Subject: City of Tallahassee - Purdom Unit 8 Project
Edited Pages of Site Certification Application

Enclosed please find 18 sets of edited pages to the subject Site Certification. As we have discussed, these pages contain edits of the text, figures, and tables which clarify certain issues in response to agency questions previously asked and answered, or simply correct typographical errors. These editorial changes are provided for the convenience of all reviewers and do not represent a revision to the project.

Purdom Unit 8

Figure
2.2.1-3

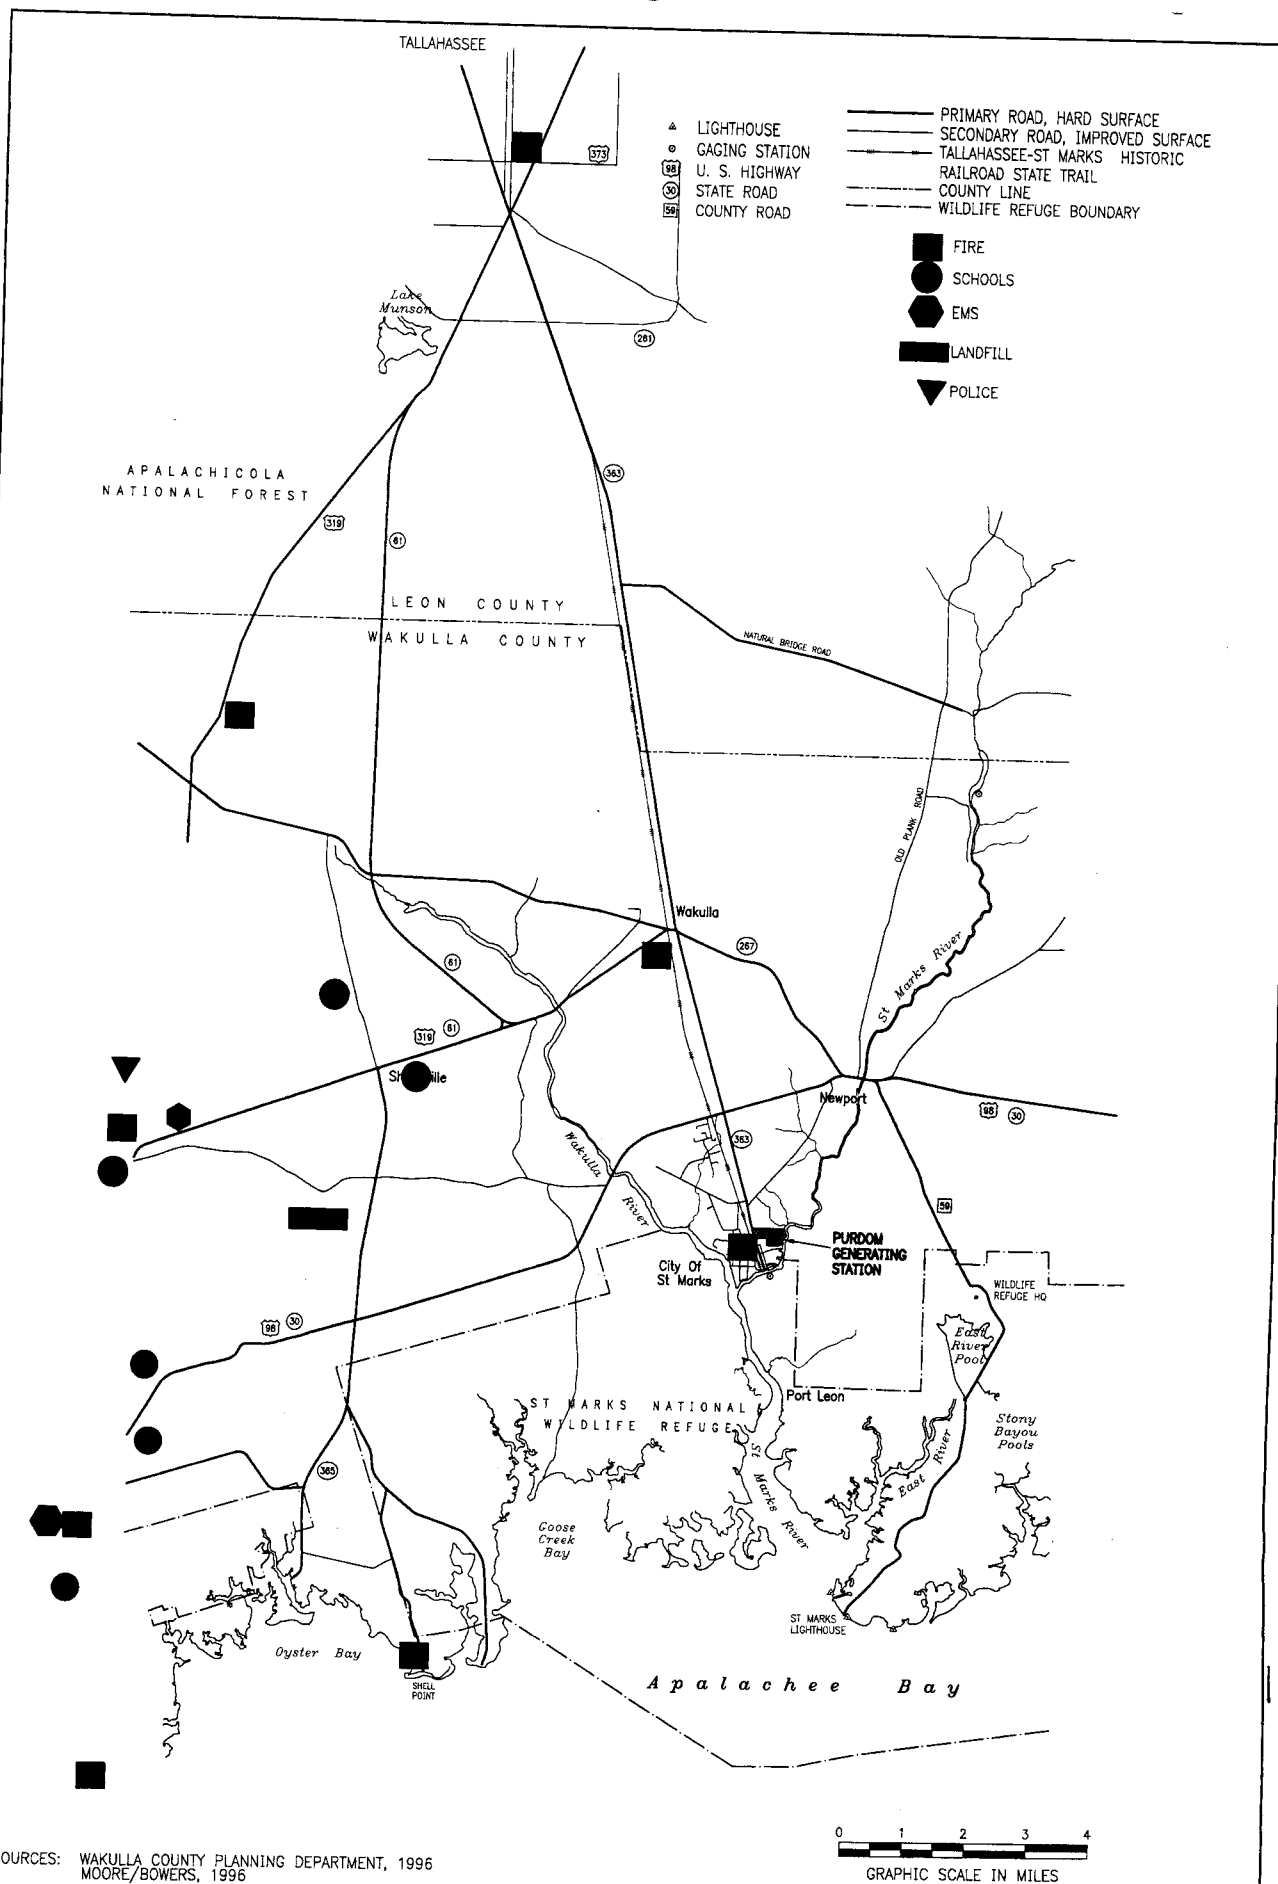
2.2.1-5 (Figure 2.2.1-3)	2.2.1-5 (Figure 2.2.1-3)		Clarification of key
Section 2.2.7			
2.2.7-25 (Figure 2.2.7-21)	2.2.7-25 (Figure 2.2.7-21)		Supplemental information
Section 2.3.4

Figure
2.3.4-41

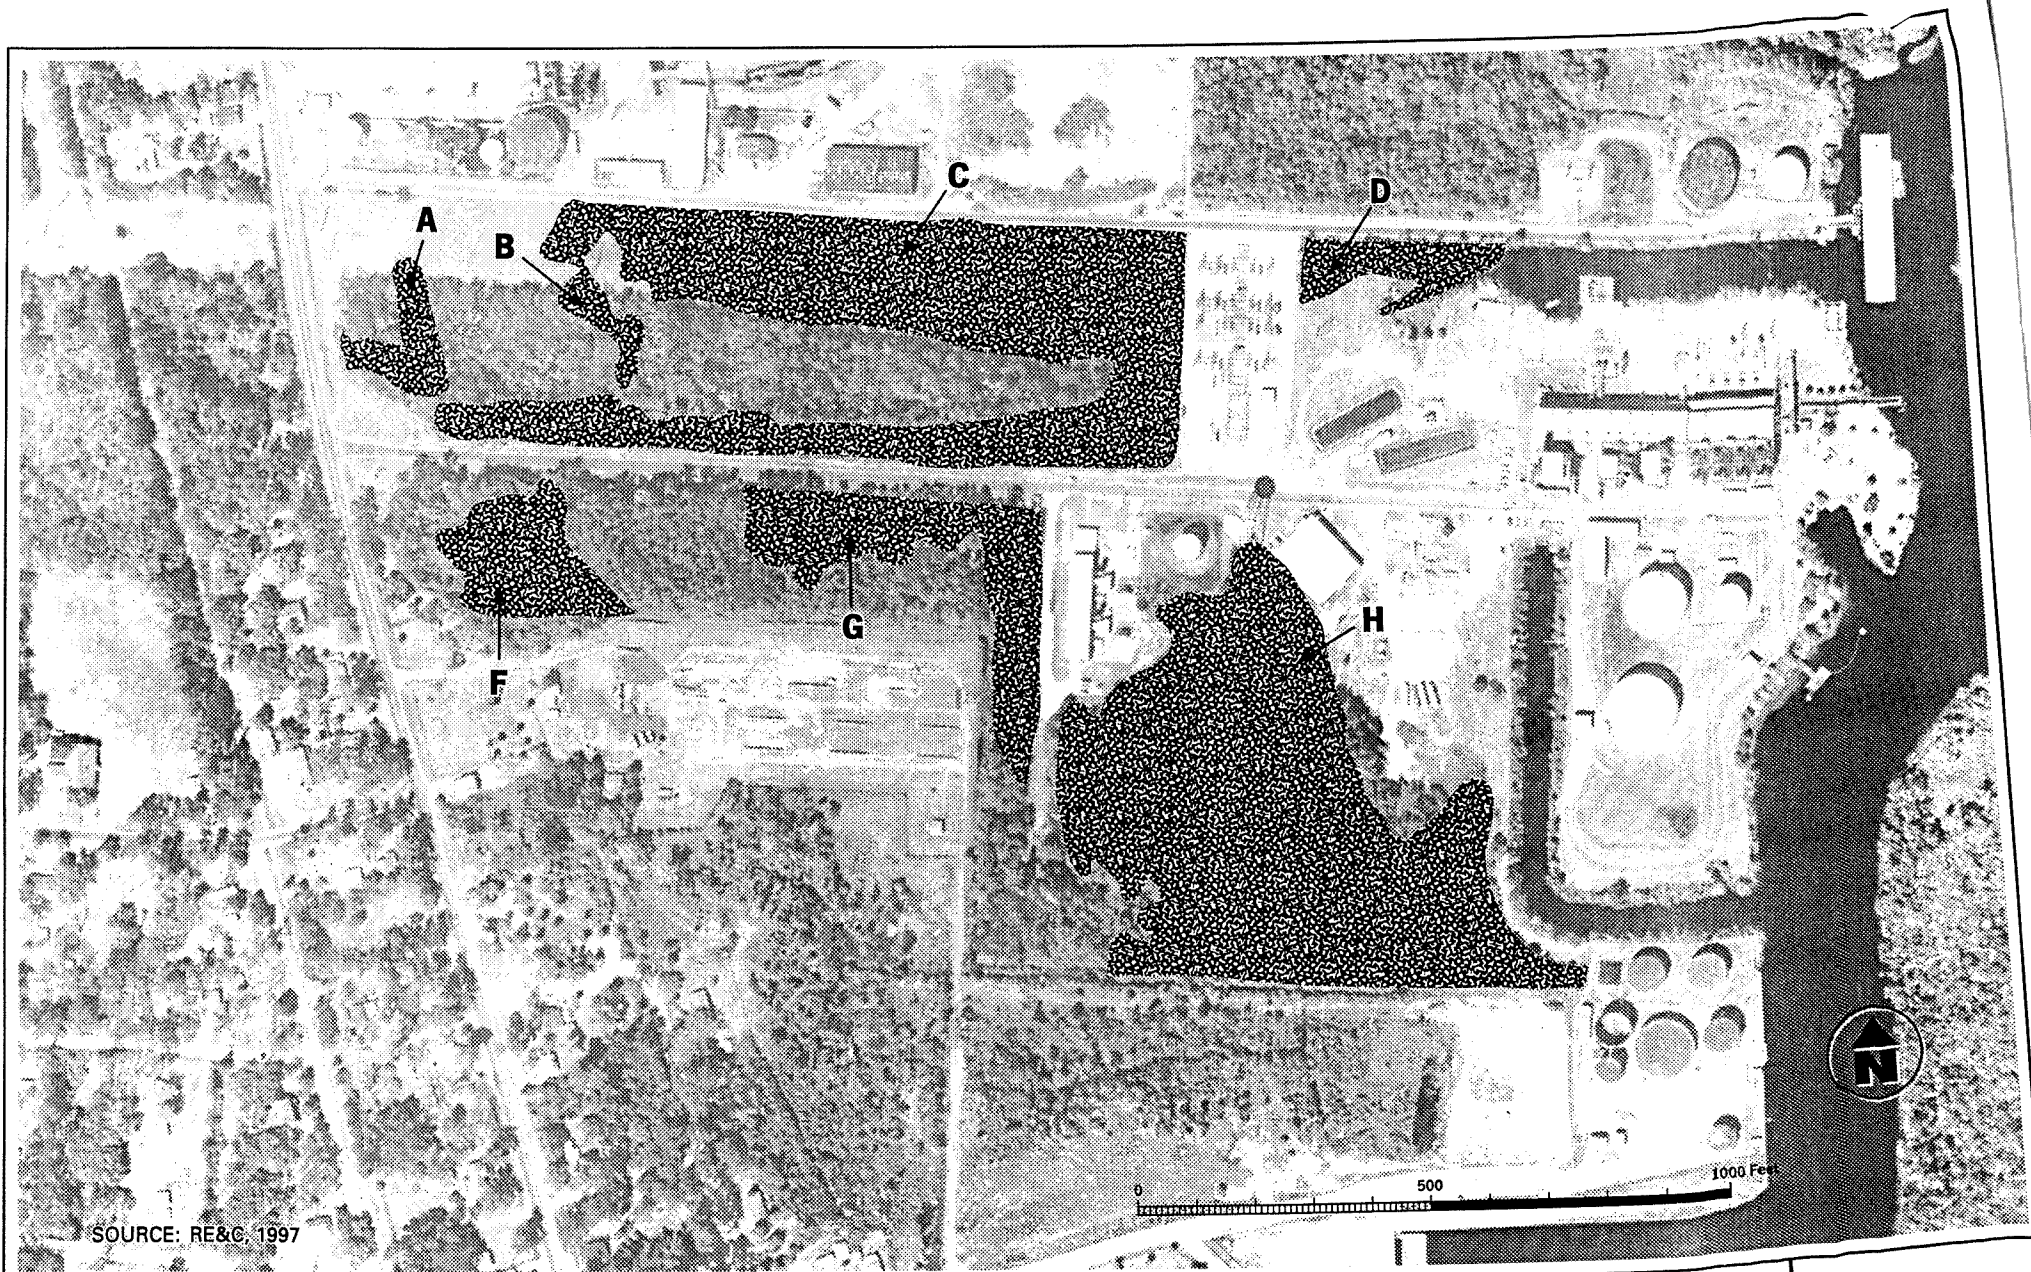
2.3.4-62 (Figure 2.3.4-41)	2.3.4-62 (Figure 2.3.4-41)		Scale correction
Section 3.0			
i thru iv	i thru iv		Page number changes
Section 3.2			
3.2-4 (Figure 3.2-3)	3.2-4 (Figure 3.2-3)		Foundation elevation correction
Section 3.4

Figure
6.1.7-2

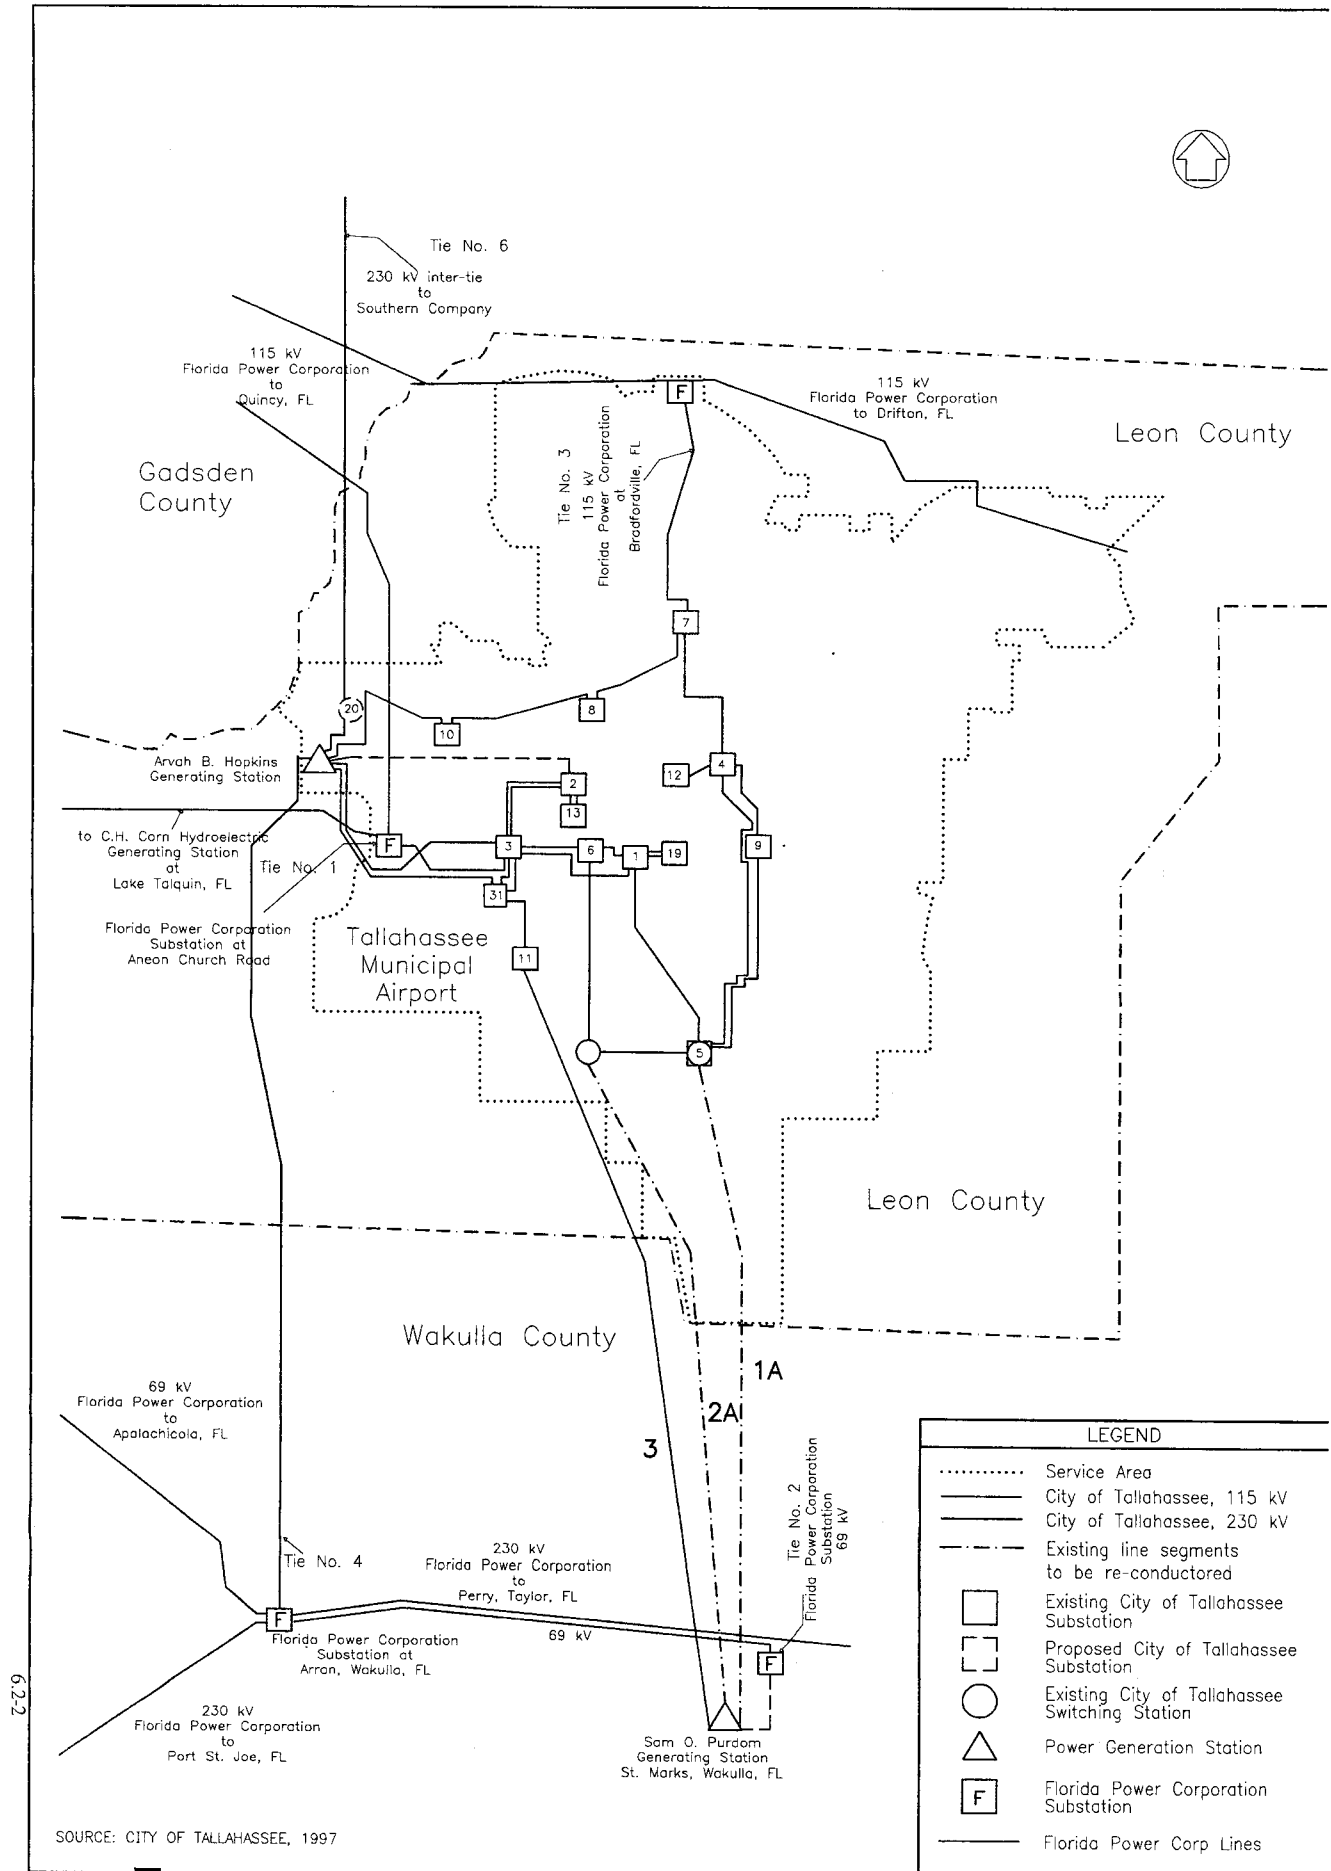
6.1-10 (Figure 6.1.7-2)	6.1-10 (Figure 6.1.7-2)		Clarification, correct scale
6.1-12	6.1-12		Supplemental information
Section 6.2			
6.2-2 (Figure 6.2.1-1)	6.2-2 (Figure 6.2.1-1)		Clarification
Section 7.2

Figure
7.2.2-1

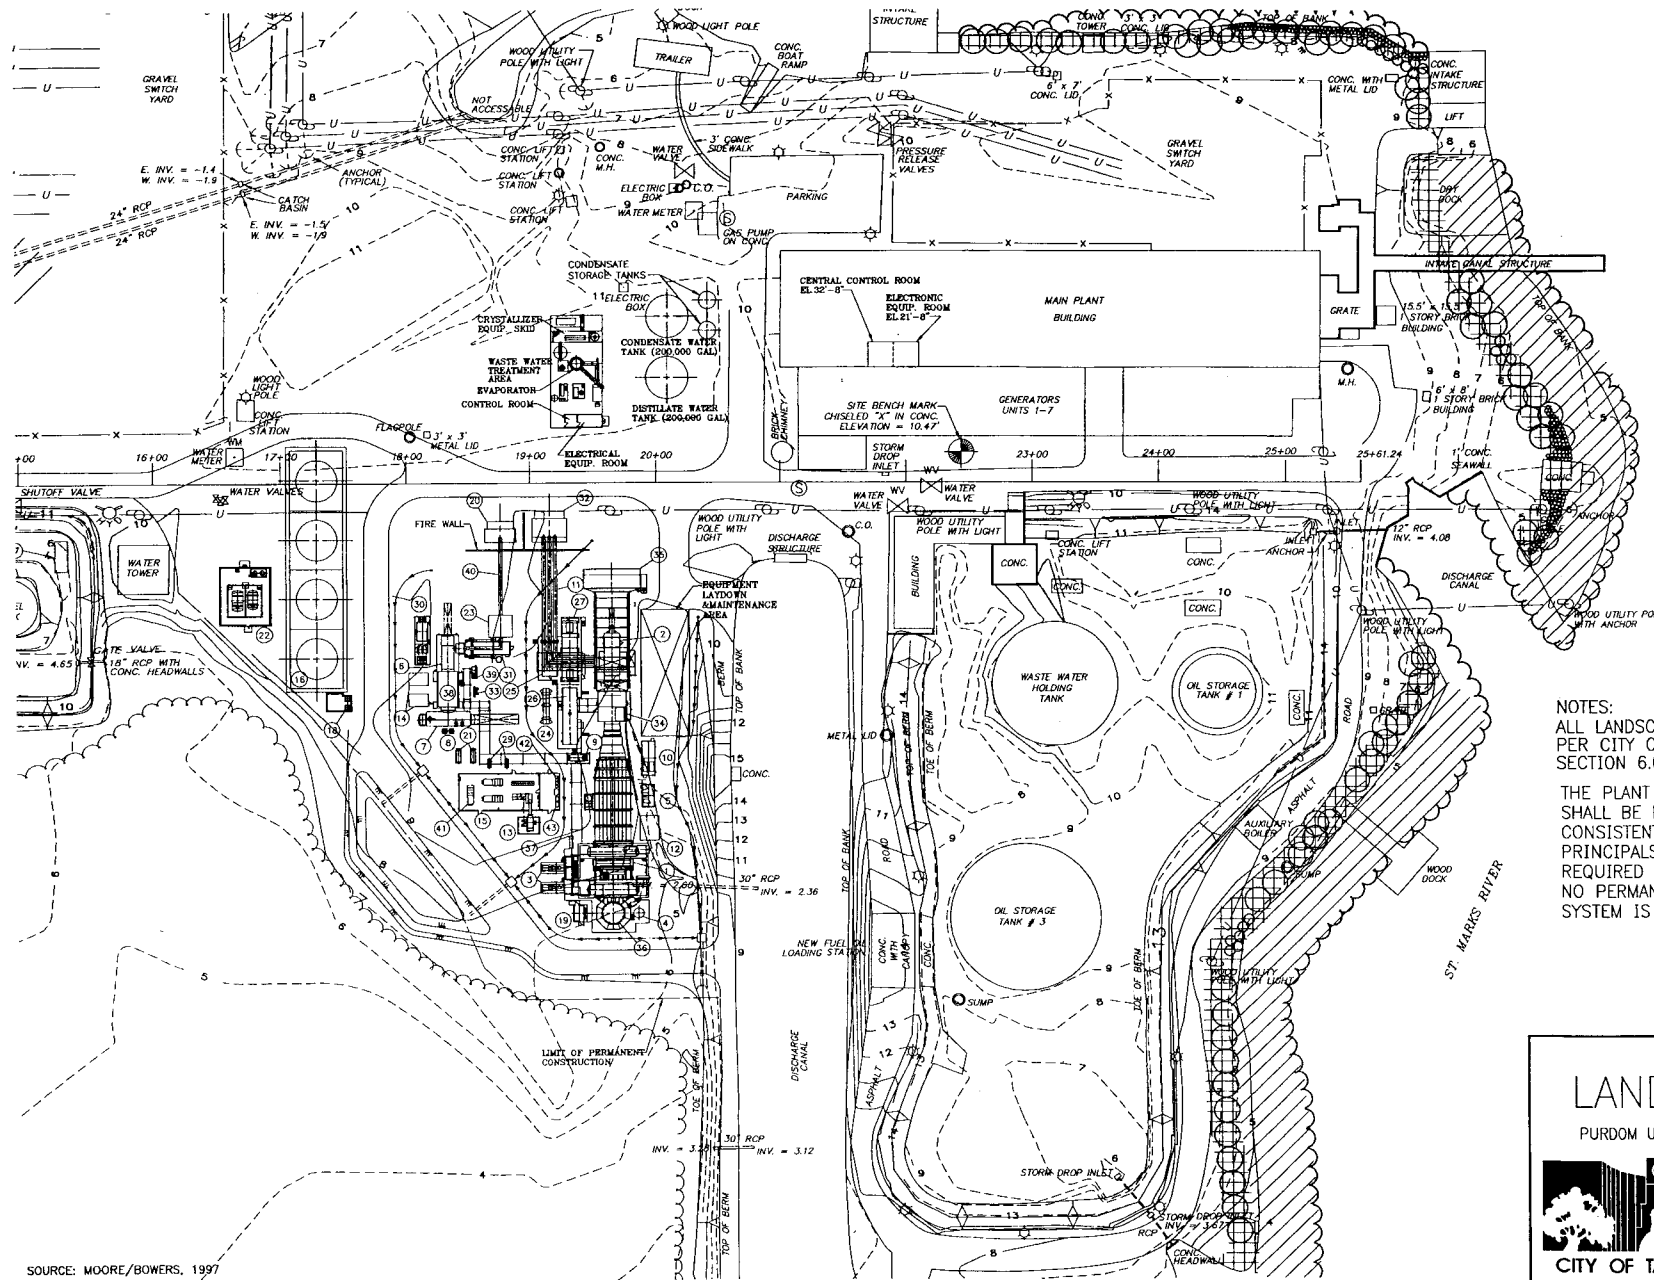
7.2-1 (Table 7.2.1-1)	7.2-1 (Table 7.2.1-1)		Clarification
7.2-6 (Figure 7.2.2-1)	7.2-6 (Figure 7.2.2-1)		Clarification of tank numbering
